CERTIFICATE OF APPROPRIATENESS PLACARD

914 W SOUTH STREET

Project Description:

- Replace site steps;
- repair/replace front walk.

>> <image1.JPG>

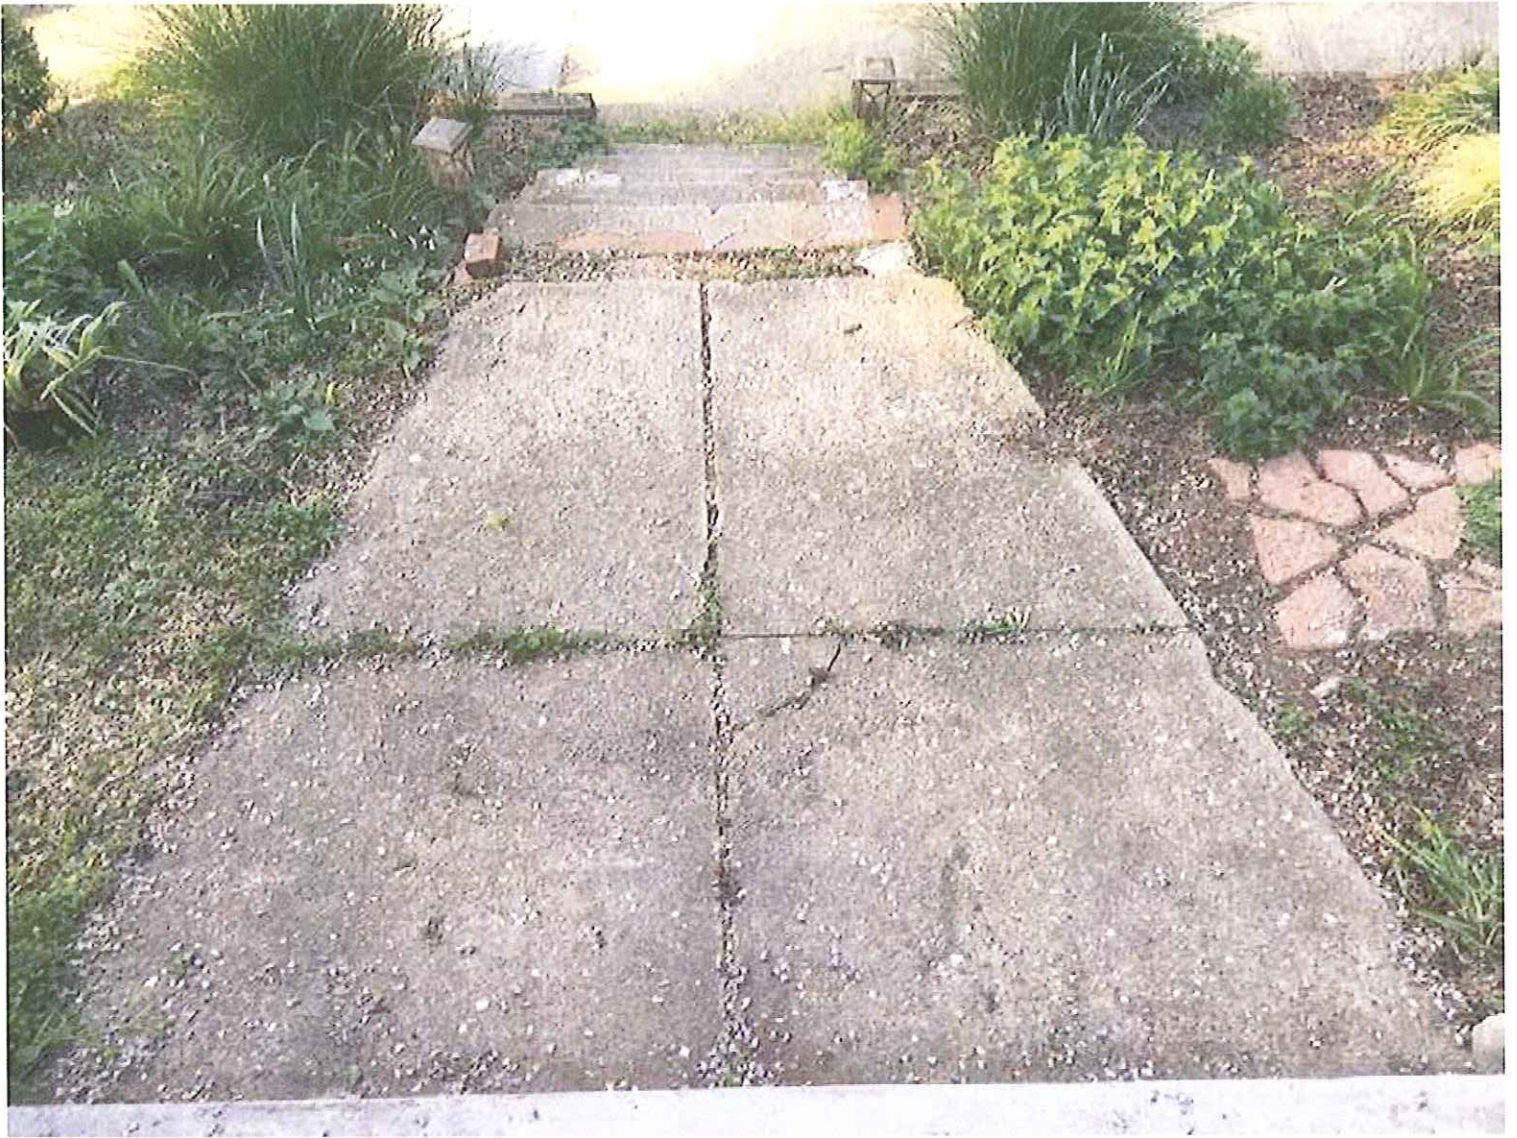
>> Attached is a photo of the current state and my neighbors steps which we plan to emulate. We will replace the landing at the top and the steps.

Existing Stairs

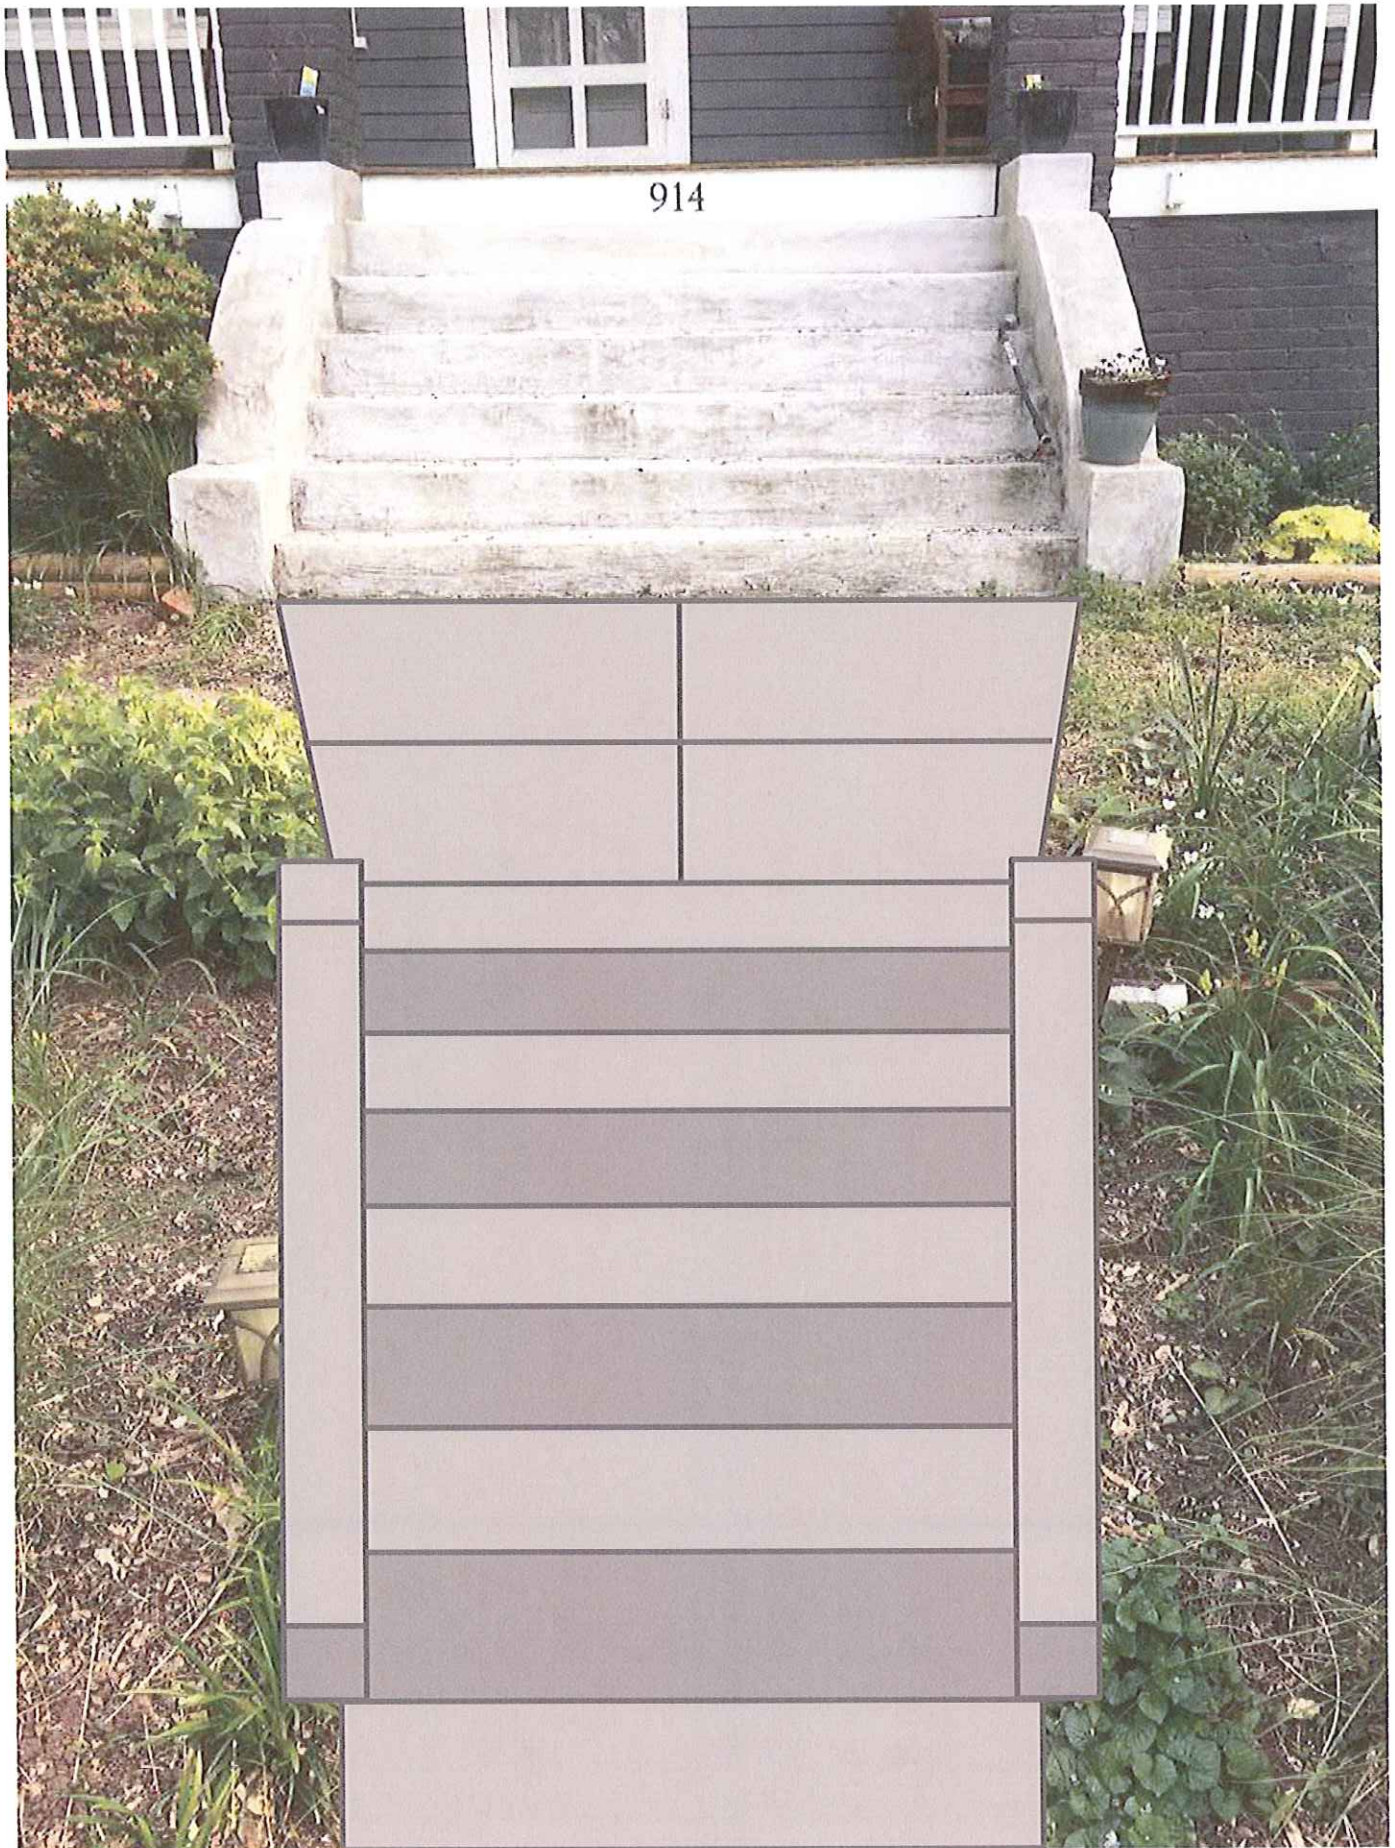
- Please confirm that the new concrete will have a water-washed finish.
- Please provide a drawing that is either to scale or has dimensions. This should include the tread and riser dimensions. ***The current steps are not consistent in depth and height (part of your problem I'm sure). I need an estimate of what the new dimensions will be. ***Attached is a mark-up with the known dimensions and lines where the new dimensions are needed***

The actual step and riser dimensions may vary depending on what he finds when he digs up the current steps and gets the final measurements. Step 10-14" and riser 6-8", all to code.

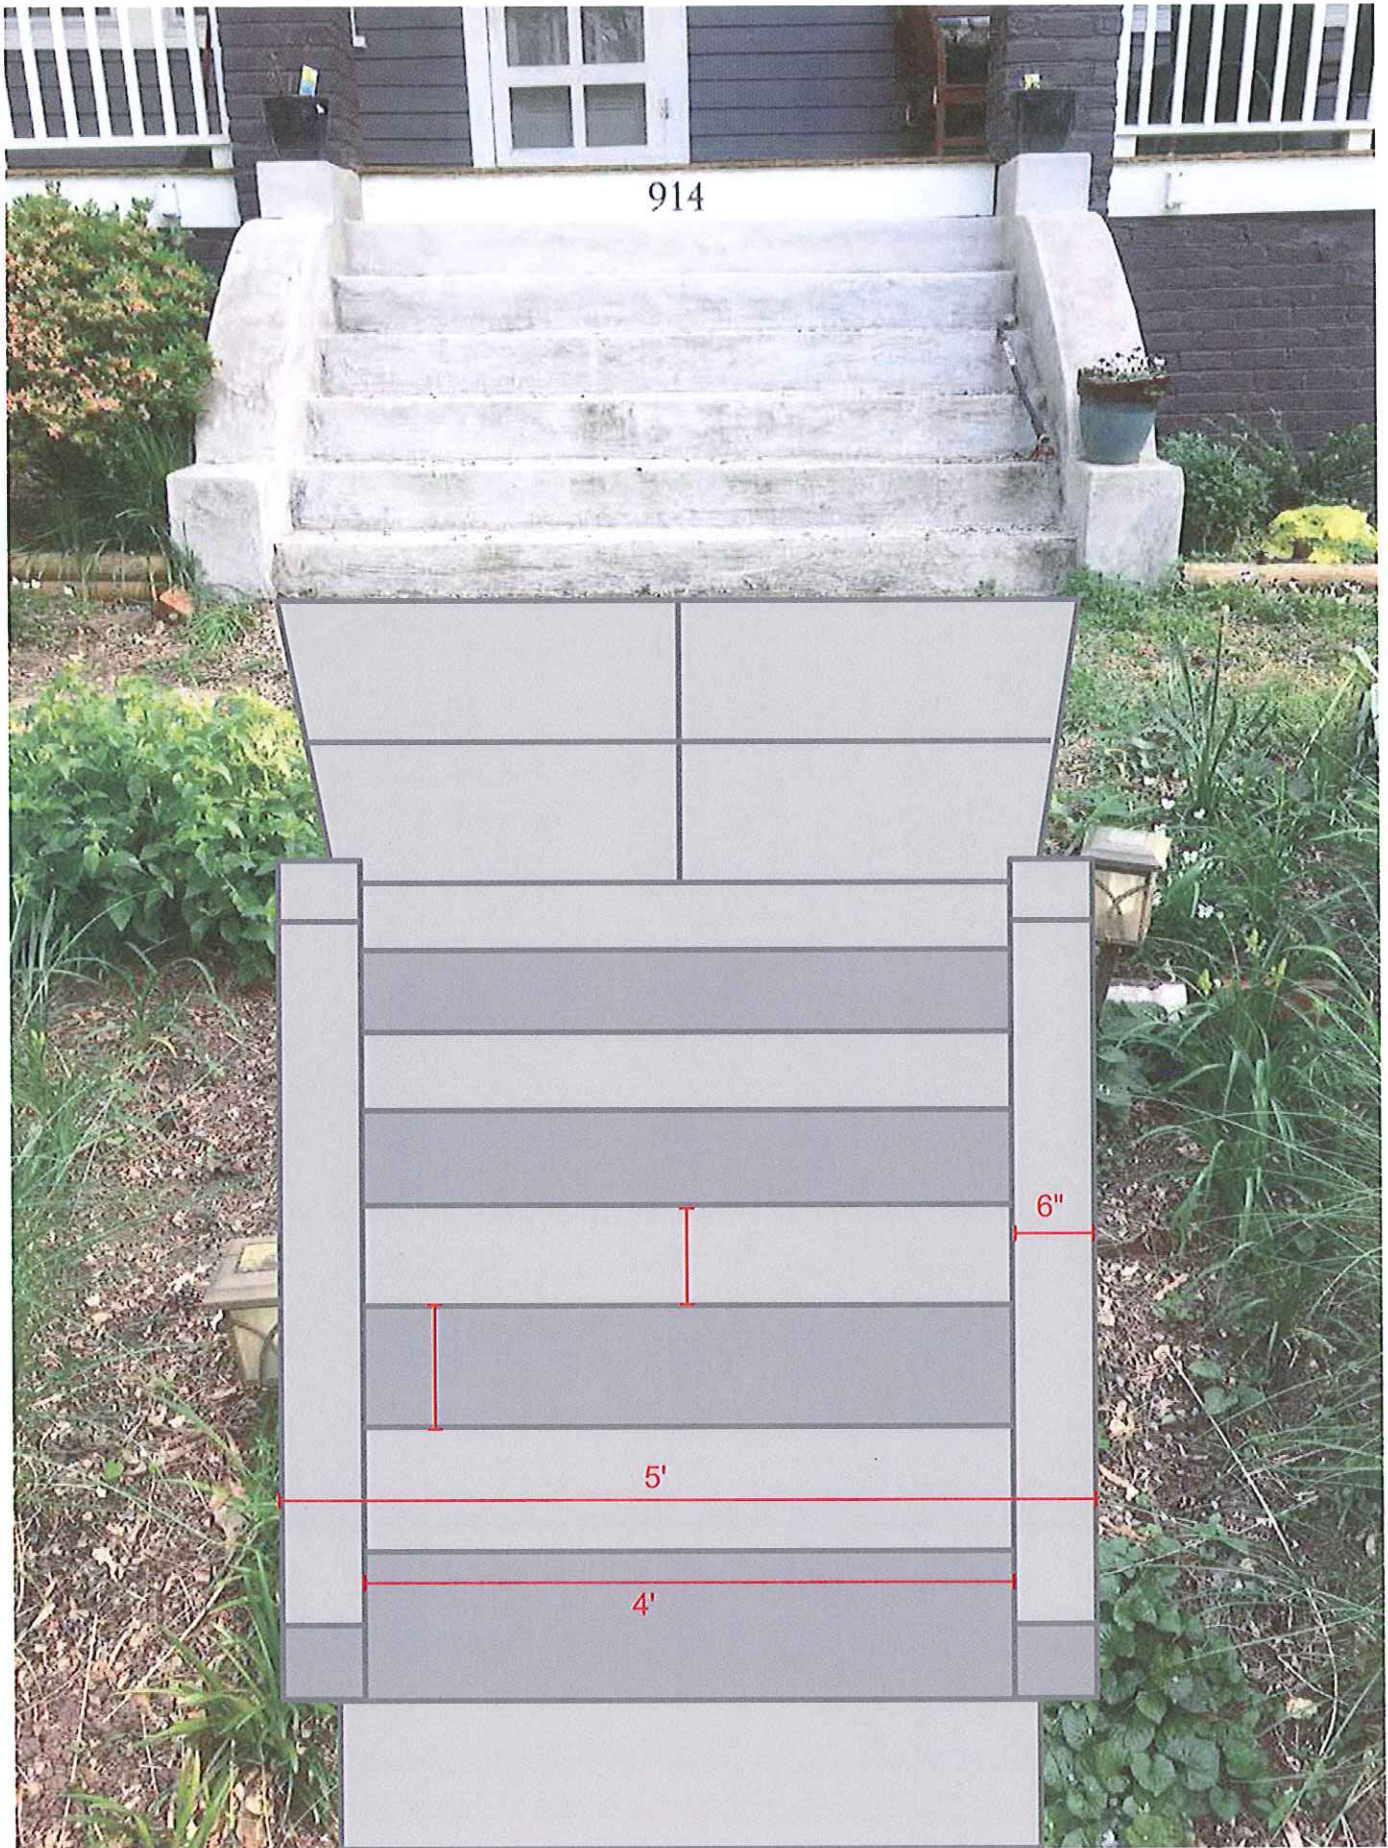
- Will the new cheek walls on the lower steps have a curve similar to the house steps or be a flat slope? ***I found a photo you previously sent of a neighbor's steps you plan to emulate (attached). Is that still the case?***

We will make the knee walls similar to our neighbors as duplicating the upper steps would be difficult.
